From: Welker, Molly [mwelker@bristol-companies.com]
Sent: Thursday, April 16, 2009 4:24 PM
To: james.spires@alaska.gov
Cc: Cossaboom, Carey C POA; Woods, Travis; Johnson, Steve
Subject: Proposed Landfill Cap Northeast Cape, AK

Summary of the 2009 Northeast Cape Landfill Cap Project

Background of the Cargo Beach Road Landfill

Figure 1. Cargo Beach Road Landfill sampling locations.

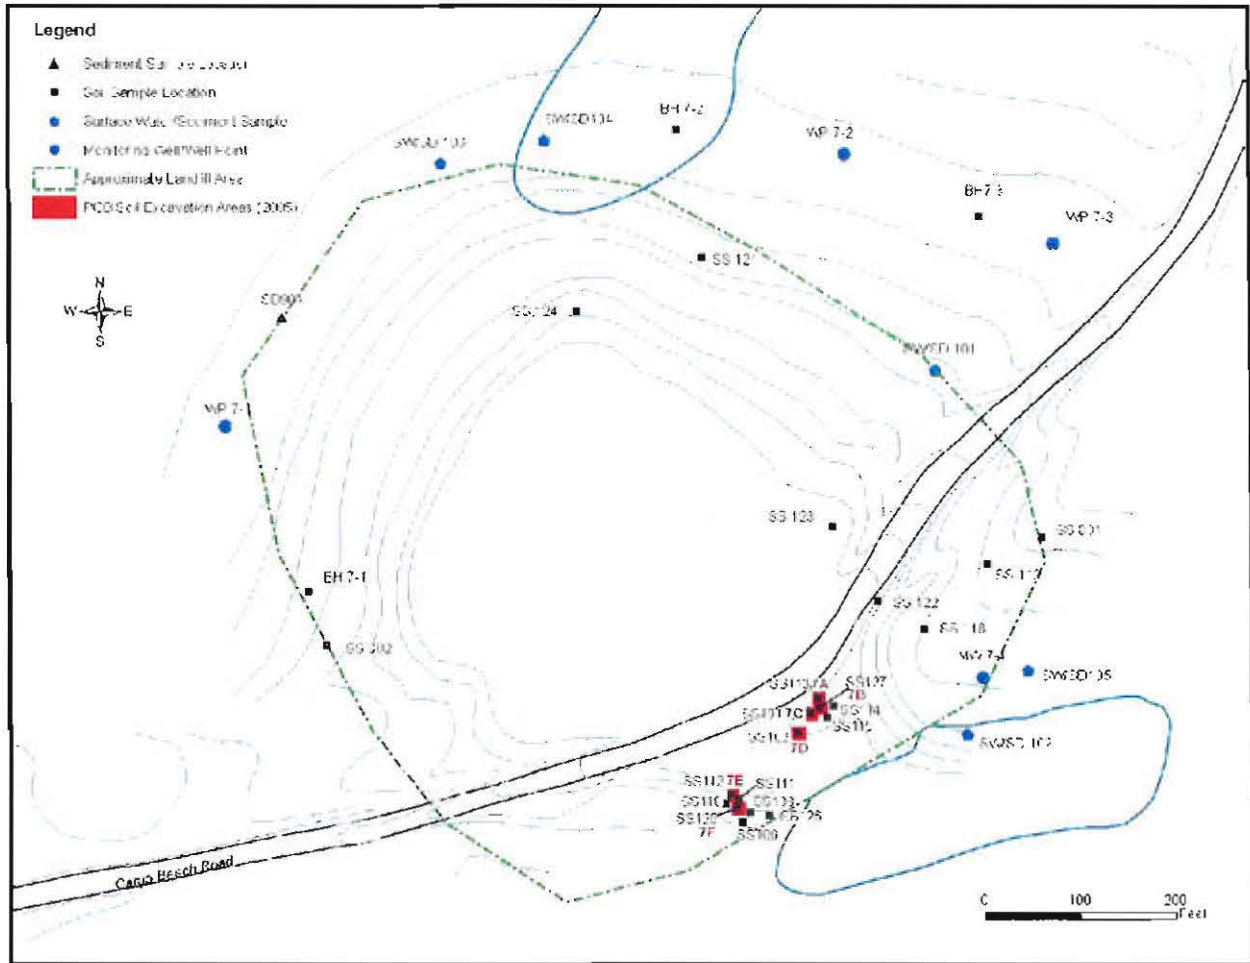
The map in the document is not very legible, so I have these questions.

1. Where are the monitor wells and what is the depth to groundwater?
2. What is the direction of GW flow?
3. Regardless of action levels, have GW samples taken over time indicated an increase in contaminant concentrations over background?

The following information is taken from the MWH 2001 Phase III RI, Northeast Cape, Alaska - Final Report on the Groundwater and Surface Water Sampling (Section 2.1.4.4). An attached table shows the analytical results and another image of Figure 1 is attached. The well points (WP 7-1, 7-2, and 7-3) are shown as blue dots on Figure 1. I can't find any information on MW 7-4 shown on Figure 1. I believe this is the only groundwater samples that have been collected at this site.

To evaluate any impact to groundwater, three well points were installed 3 to 6 feet bgs downgradient of the landfill (Figure 2-4). WP 7-1 was installed near the western edge of the landfill area. WP 7-2 and WP 7-3 were installed 235 feet apart, approximately 125 and 165 feet, respectively, north of the north-northeastern border of the landfill area.
